Docket Nos. 70-00270
30-02278-MLA
ASLBP No. 90-613-02-MLA
RE: TRUMP-S Project

DECLARATION
OF
TRUMP-S REVIEW PANEL

REBUTTAL DECLARATION OF TRUMP-S REVIEW PANEL

Concentration of Curies Per Cubic-Meter of Air at Various Distances Given 0.3 Grams (0.0246 Ci) of Plutonium

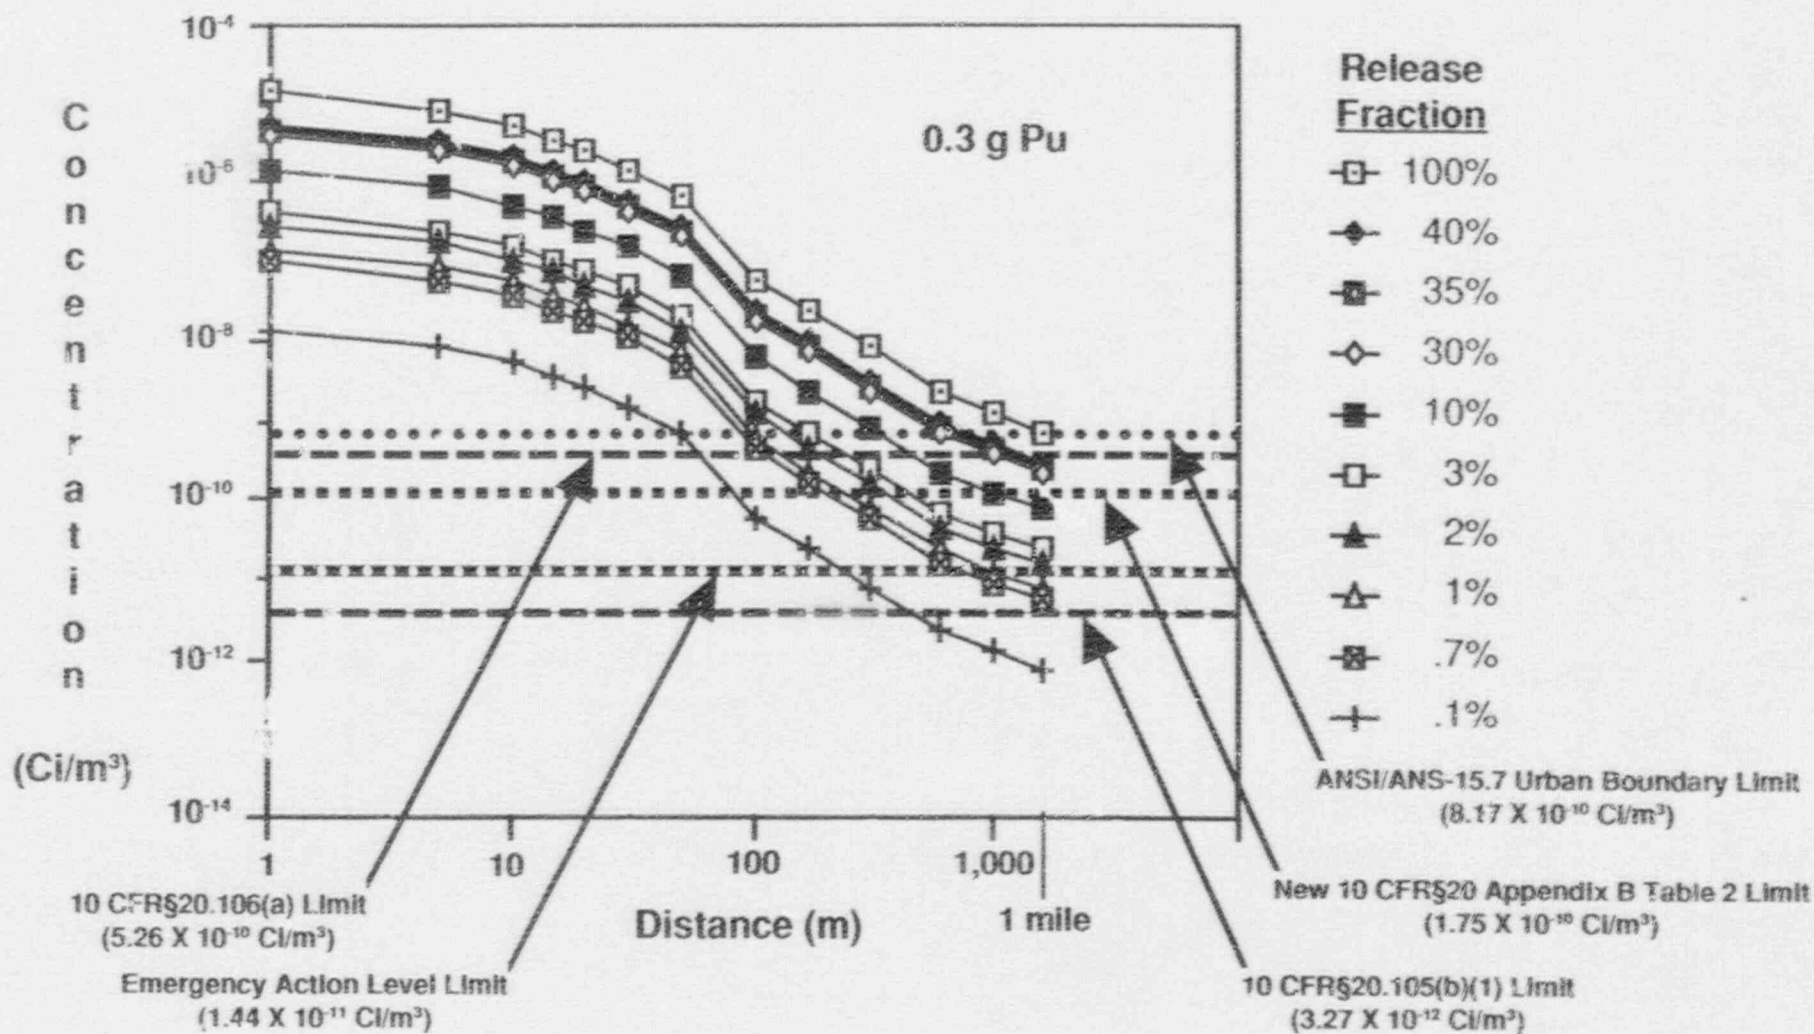
88. The graphs and tables are for the two primary transuranic elements of concern: plutonium and americium. Dispersion for accidents involving each element is calculated at various distances for three starting quantities of material: the licensed possession limit, the licensed in-process limit, and the Applicant's asserted normal process quantity. For each of these three cases, for each element, concentrations are calculated at various distances for a range of release fractions: the NUREG-1140 figure for overheating incidents involving plutonium metal without an external fire (.001), the NUREG-1140 figure for solvent fires involving actinides (up to .007), the 1% release figure used by DOE and found in the VIXEN experiments, the 2% figure found in a 25-minute fire by Seehars, the 3% figure found in an hour fire by Hilliard, the 10% fraction found in a number of experiments by Mishima, and the 30-40-50% fractions found in numerous other tests by Mishima. These last tests led Mishima to conclude: "Releases are such...that to a first approximation half of the active material may be considered to be entrained. A conservative position would be to assume that all such material would be airborne." (Mishima and Schwendiman, "The Amount and Characteristics of Plutonium Made Airborne Under Thermal Stress," BNWL-SA-3379.) This "conservative position" thus represents the top curve on the graphs.

92. Americium is clearly the limiting case. Concentrations so far in excess of permissible are found that it is clear that even were one to assume a fully functioning HEPA filter and a stack release--which are totally unreasonable assumptions, for the reasons detailed earlier, not least of which is the emergency plan to shut off the stack in case of accident--concentrations in excess of acceptable standards are found for most combinations of reasonable release fraction and starting inventory.
